SERVICE BULLETIN

SB651

SUBJECT: CAPACITOR INFORMATION AND INSTALLATION FOR D-2000 AND D-3000 SERIES MAGNETOS.

REASON FOR BULLETIN: To provide information and instructions when troubleshooting difficulties associated with capacitors in the D-2000 and D-3000 Series Magnetos, and to provide revised installation instructions for these capacitors.

FIGURE 1
TYPICAL D-2000 / D-3000 CAPACITOR

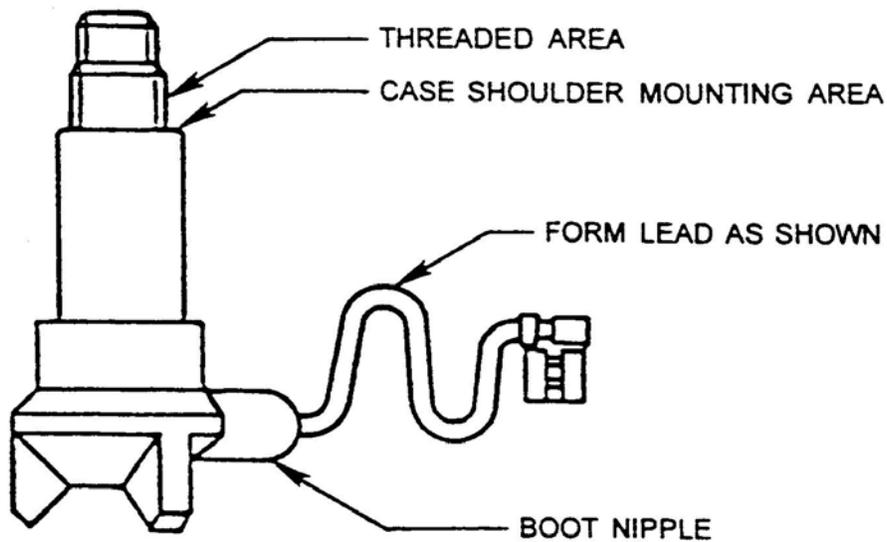
- a. Ensure each capacitor to be installed is the correct part number for the magneto. Despite similarities in appearance, capacitors for D-2000/D-3000 Series Magnetos have differing capacitance values and boot configurations depending on the number of cylinders the magnetos fire. Capacitor applications are as follows:

- b. Ensure capacitor mounting surface inside the harness cover is clean and free of corrosion. If necessary, brighten harness cover in the inside capacitor mounting area with ONLY a clean, fresh nylon scouring pad.
- c. Using ONLY a different clean fresh nylon scouring pad, remove contamination and corrosion from capacitor case shoulder and threads as necessary. See Figure 1
- d. Form capacitor leads as shown in Figure 1.
- e. Install the two capacitors in their respective places in the harness cover. Secure each capacitor with lockwasher and nut, centering the boot nipple between the harness silicone grommets. Apply 60 to 70 inch pounds torque to each nut. NOTE... To ensure correct alignment of capacitor boot nipple, the harness cover and capacitor may be temporarily mounted onto a magneto while the capacitor securing nut is tightened.
